PERMIT

SEWAGE DISPOSAL SYSTEM

P 27845

A Repair

P 27845

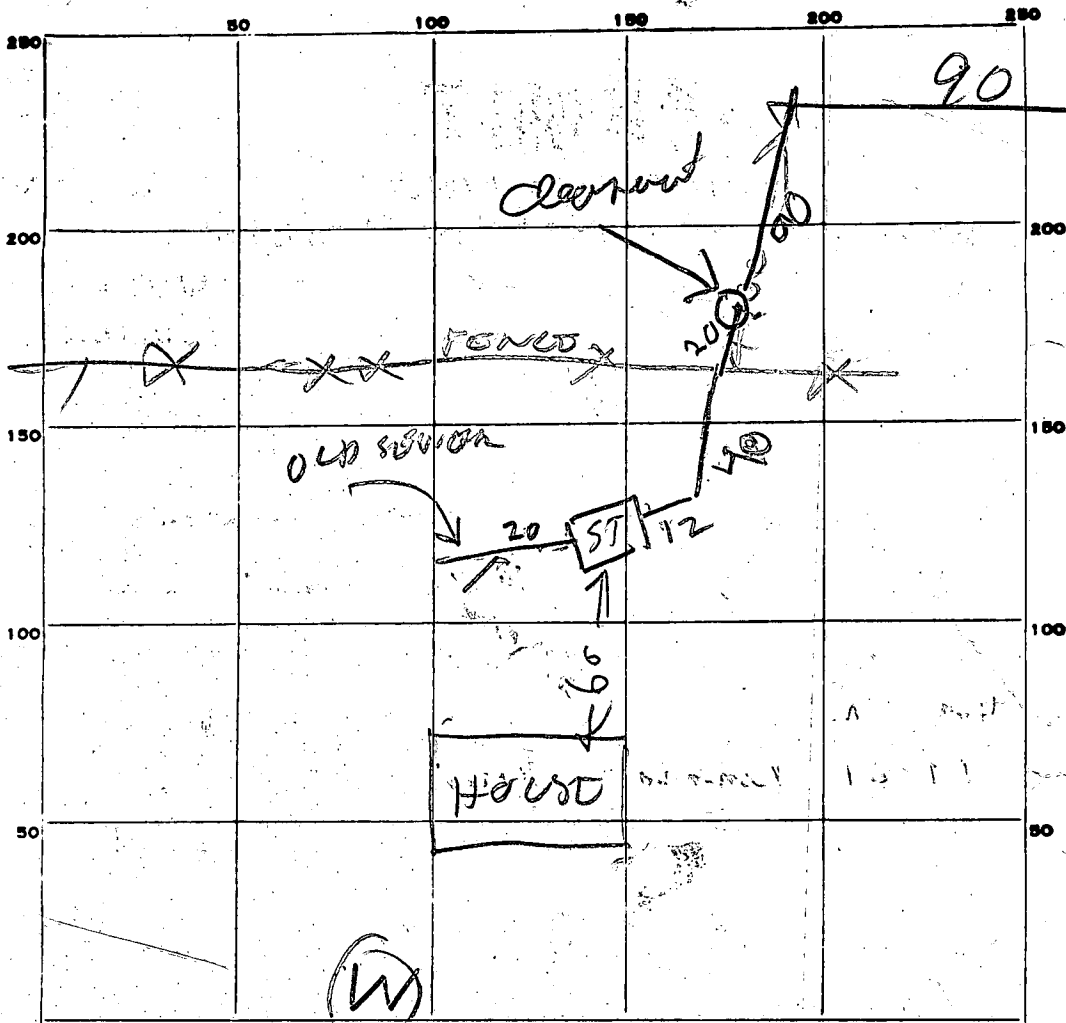
Repair - recommendations see original sheet.

A.M. Phone 7/26/78 3 Bedroom house per M. Arnold 1000 gallons

trench 90' 6'-7' or more stones under

pipe - pipe no closer than 2' of original soil in trench.

REMARKS
8/2/78 COVER TANK & PIPES TO YARD FENCE
ADD STONE TO DITCH INSTALL
REMAINING SEWERS & CALL RH
8/4/78 - SEWERS INSTALLED & STONE
ADDED TO DITCH
